Bulletin No:	B391CRM166-0
Release Date:	October 23, 2009
Effective Date:	Immediately
Supersedes:	N/A
Completion Date:	See Text
Page:	1 of 3

SERVICE BULLETIN

Ride Name: FALLING STAR (Park and Portable Models)

Abstract of Issue:
Vehicle Axle NDT and Replacement

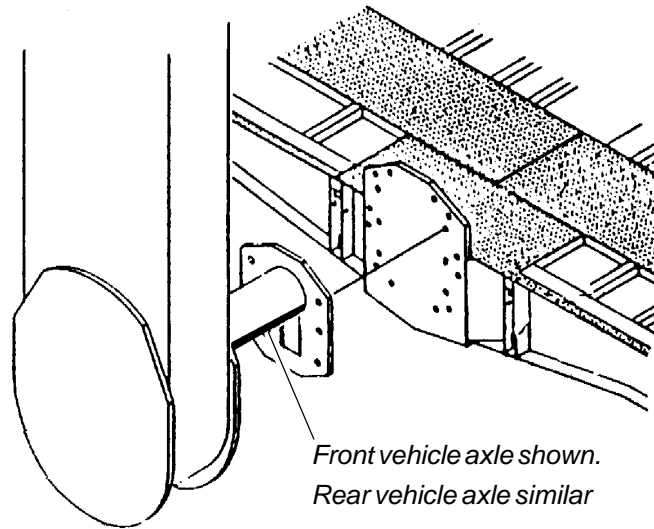
An accurate calculation of the total accumulated axle revolutions is necessary to determine what action must be taken. A sample worksheet is provided on the following page of this bulletin.

AXLES WITH LESS THAN 3 MILLION REVOLUTIONS MAY CONTINUE OPERATION until a total of 3 million revolutions is reached. Revolution calculations must be maintained and updated **annually**. It is recommended that these calculations be readily accessible for reference at all times.

AXLES WITH OVER 3 MILLION REVOLUTIONS MUST BE TAKEN OUT OF SERVICE IMMEDIATELY. Before the ride can be returned to service, both axles must be removed from the ride for either NDT inspection or replacement with new parts, at the owner's discretion.

- If NDT is performed and no indications are found, the axles can be placed back into service for a period of no more than one year. The NDT inspection of both axles must be performed **annually**.
- If NDT is performed and indications are found, the axles must be replaced with new parts. **DO NOT ATTEMPT TO WELD OR OTHERWISE REPAIR THE VEHICLE AXLES.**
- If, for any reason, the axles are replaced with new parts, the ride can be operated for up to 3 million additional axle revolutions. No annual NDT is required during this period.
